DEPARTMENT OF NATURAL RESOURCES
DIVISION OF OIL, GAS AND MINING

March 11, 2002

RE: Technical Field Visit, Topsoil Stripping, Savage Industries Inc., Savage Coal Terminal, C/007/022

p0003409.jpg

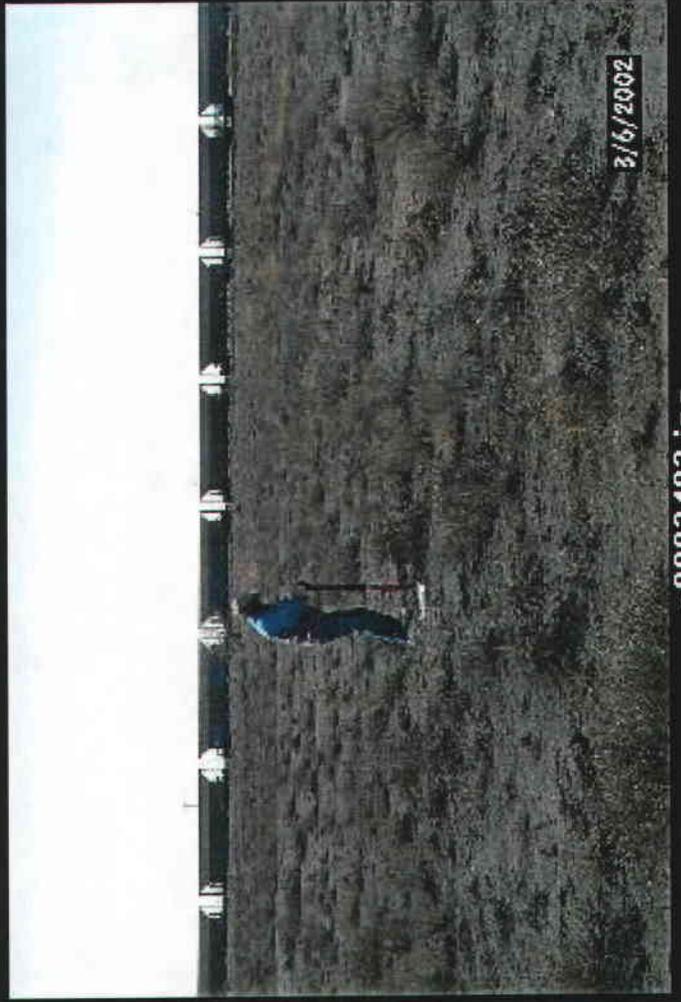
indicate that topsoil would not be salvaged from the area. Visual observation of the flagged area revealed almost 100% cover by non-weedy species, predominantly saltgrass (*Distichlis*). For this reason, a soil sample was composited from eight subsamples within the flagged area (Sample #1, attached image P0003409.jpg). Subsamples were drawn from 0 – 6 inches, the projected depth of soil salvage.

The flagged area soils had good structure and aggregation and supported a thriving vegetative community. The pH and EC of the flagged area soils was suitable for native plant species growth. Therefore, soils within the flagged area should also be included for topsoil salvage.

p0003422.jpg

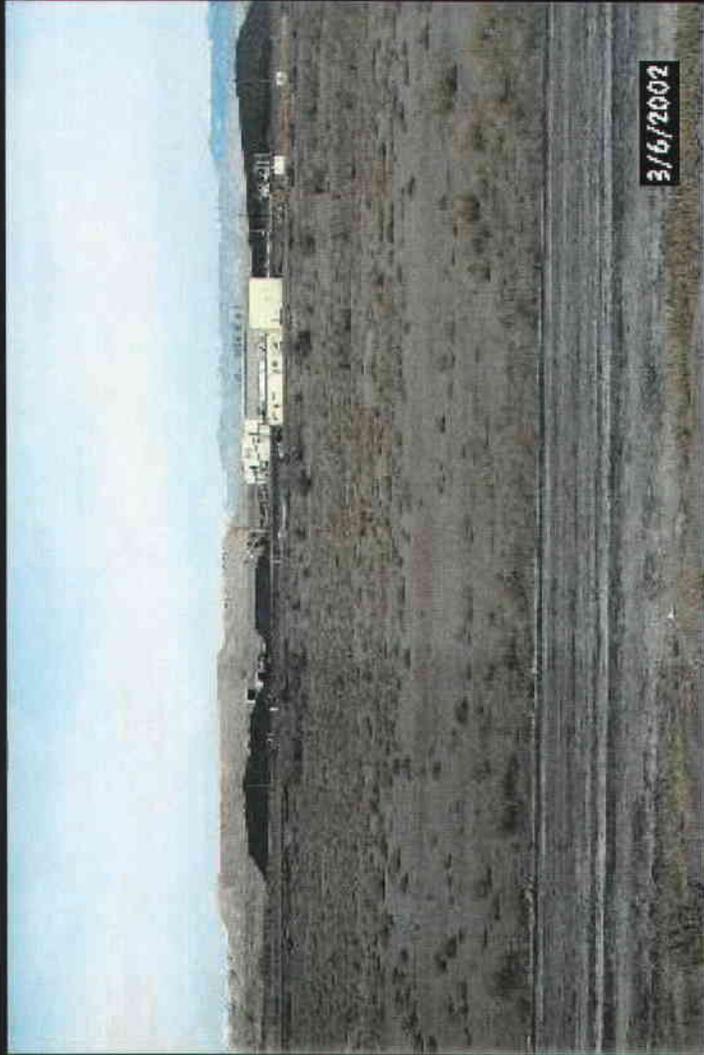
Two more soil samples were drawn from the Chipeta soil, representing: a) the southeast area supporting only sparse vegetation (Sample #2, attached image P0003422.jpg) and b) northwest area supporting a vegetative community of shrubs and grasses (Sample #3, attached image P0003423).

Sample #2 (southeast Chipeta soils) was a composite of 8 subsamples drawn from a 0 – 6 inch depth. Sample #3 (northwest Chipeta) sample was a composite of 4 subsamples from 0 – 6-inch depth. The disparity in the number of subsamples was due to the soil development in Sample #3 soil that allowed the soil to remain aggregated on the spade and provided a greater sample size per hole to the sample bag. Sample #2 soil was very loose and had very little soil profile development, consequently, only about half of the soil lifted from sub-sample holes remained on the spade and then the hole was filled with loose, fine particles from the surface, so that a new hole had to be dug to get adequate representation of the six-inch depth soil.

The southeast half of the area to be disturbed had no aggregation or profile development. It appeared as though these soils may have been disturbed in the past by vehicle traffic, although that is not indicated by Plate 3-1. Soil aggregation and profile development in this soil type is the key to soil infiltration. Water penetration of the soils can be improved by management practices such as incorporation of organic matter into the soil (i.e. test plot #2) and by creating microbasins to trap moisture and hold it long enough for it to infiltrate (i.e. evidenced by the subsoil pile terraces). Limiting the south exposure of the piles would also increase moisture content in the soil.

p0003412.jpg

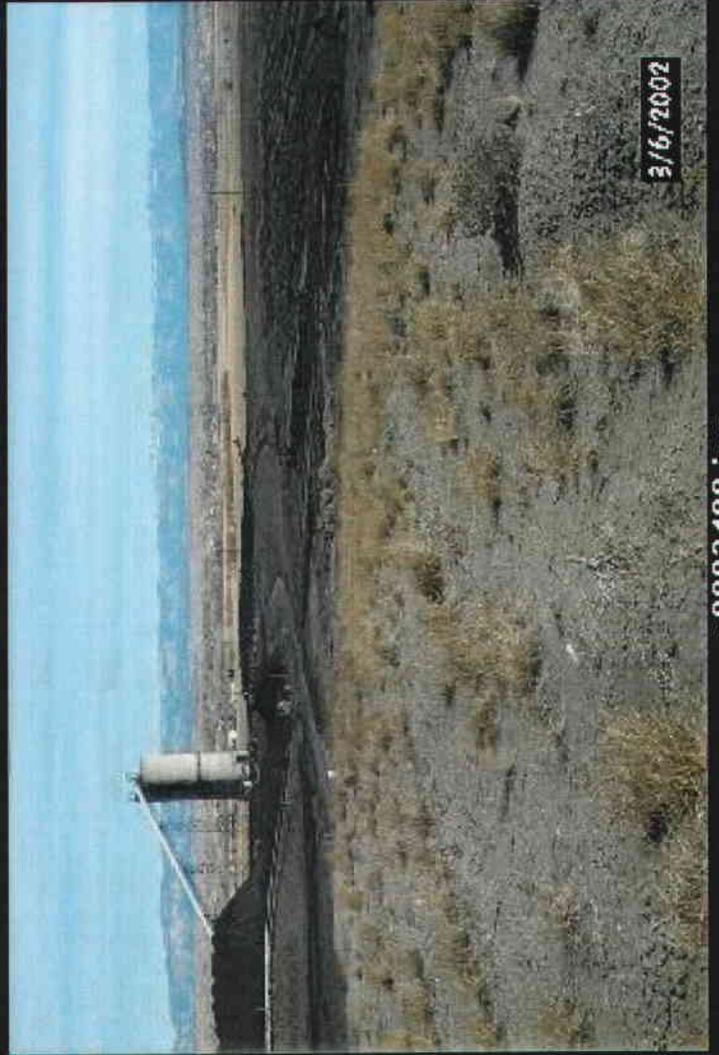
The soil to be disturbed for additional coal storage is shown on Plate 3-2 of AM02A and in the attached image P0003412.jpg. Soils had been previously mapped and are shown on Plate 8-1 as Chipeta Silty Clay, Killpack Silt Loam, and Saltair Silty Clay Loam. Soil in the vicinity of the Killpack Silt Loam and Saltair Silty Clay map units had been flagged by the Permittee to
